# mainair sports

SERVICE BULLETIN NO.29

27th June, 1988

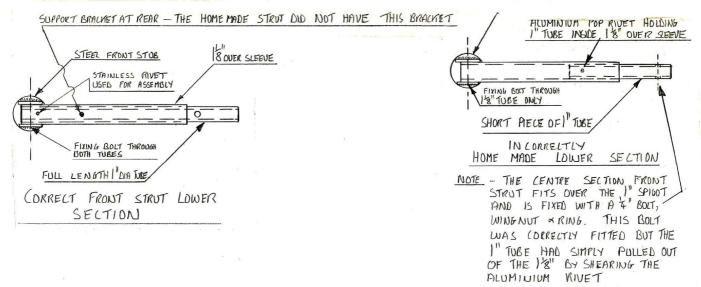
I was asked to visit the AIB at Farnborough to inspect the wreckage and discovered that all pieces of the three section front strut had been home made, not one was the correct length nor drilled or sleeved correctly. The bottom 1" section to which the centre section is fitted with a  $\frac{1}{4}$ " bolt was fitted into the 1 1/8" outer tube by only 3", was made from a piece of non standard thickness tube and was held with a single 1/8" aluminium pop rivet instead of being full length and integrally fitted to the steel stub fixing bolt.

- C). The front strut assembly should be carefully inspected and worn or elongated holes and deep chaffing will call for replacement of the part with Mainair factory issue components only. Slight chaffing is expected and acceptable where the 1 1/8" sleeve slides over the 1". The bottom section is made from a 1" tube with a 1 1/8" oversleeve and the 1" tube should be full length and exit from the bottom where it is fixed to the stub. ensure the continuity of this tube see drawing below.
